Version 2.1 Software

Addendum to the IQ plus 510 and 710 Installation Manuals

Figure 1. Partial IQ plus 710 Version 2.1 CONFIG Menu, showing location of SMPRAT Parameter

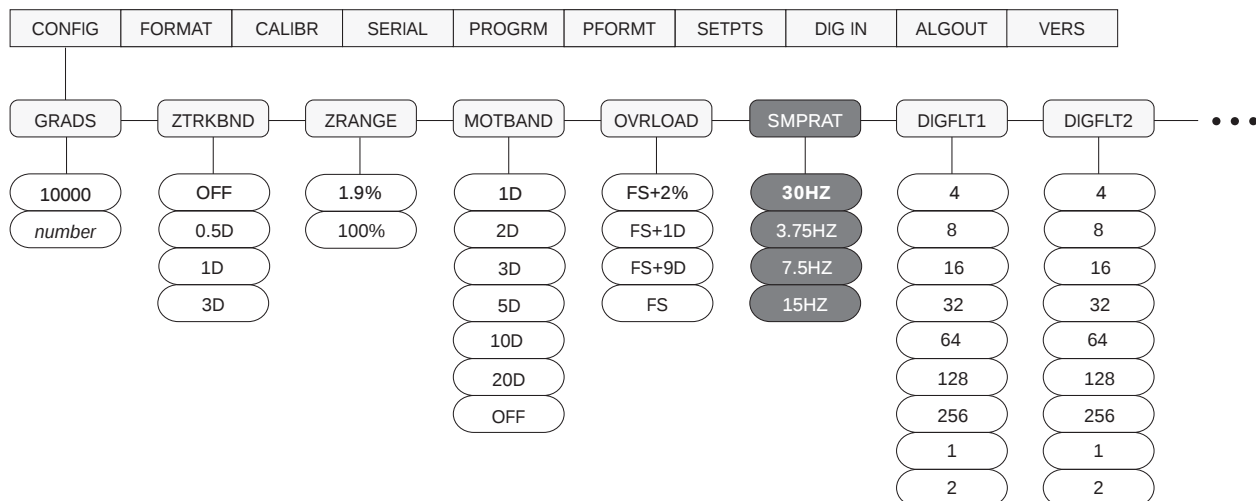
- SMPRAT parameter added to the CONFIG menu to allow selection of A/D sample rate in samples per second (see Figure 1). Lower sample rate values provide greater signal noise immunity.
- YYMMDD date format added to the DATEFMT parameter on the PROGRM menus (see Figure 2).
